Intel® Mobile Pentium® III Processor Specification Update

Release Date: November 2000

Order Number: 245306-013

Figure 7. BCLK Timing Waveform

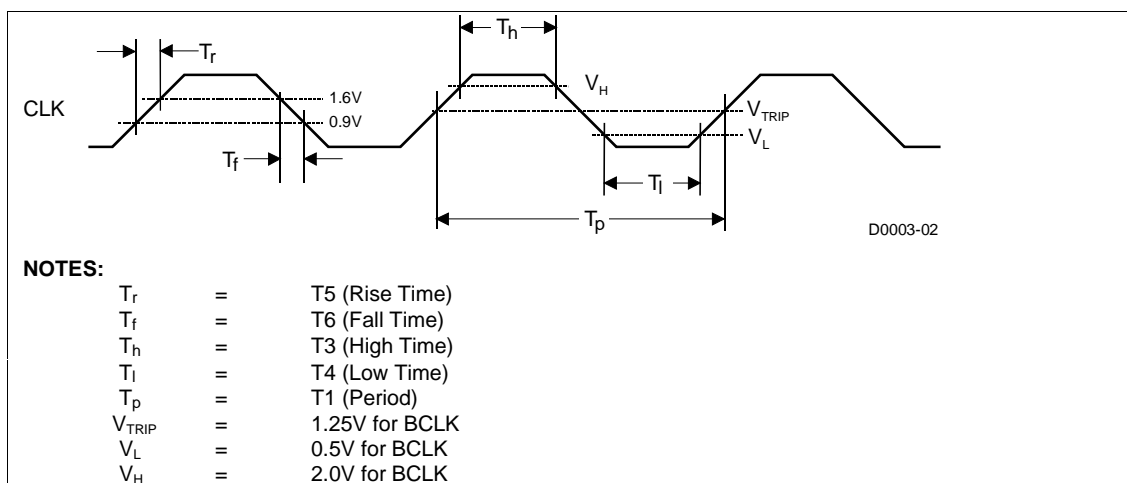
For B0 step processors, the $V_{IH,BCLK}$ Min spec is changed to 2.0V (from 1.7V for A2 step) and $V_{IL,BCLK}$ Max spec is changed to 0.5V (from 0.7V for A2 step). Due to this, new values are specified for BCLK high and low times for B0 step processors. These modifications affect corresponding specs in Table 13, Table 14, Table 24, and Figure 7 in *Mobile Pentium® III Processor in BGA2 and Micro-PGA2 Packages datasheet* (Order Number 245302-002).

The following tables and figures highlight the above mentioned BSEL[1:0] and BCLK specs modifications made for B0 step processors:

Symbol	Parameter	Min	Typ	Max	Unit	Figure	Notes
	System Bus Frequency		100		MHz		
T1	BCLK Period		10		ns	Figure 7	Note 2
T2	BCLK Period Stability			± 250	ps		Notes 3, 4
T3	BCLK High Time	2.70			ns	Figure 7	at >2.0V
T4	BCLK Low Time	2.45			ns	Figure 7	at <0.5V
T5	BCLK Rise Time	0.175		0.875	ns	Figure 7	(0.9V – 1.6V)
T6	BCLK Fall Time	0.175		0.875	ns	Figure 7	(1.6V – 0.9V)
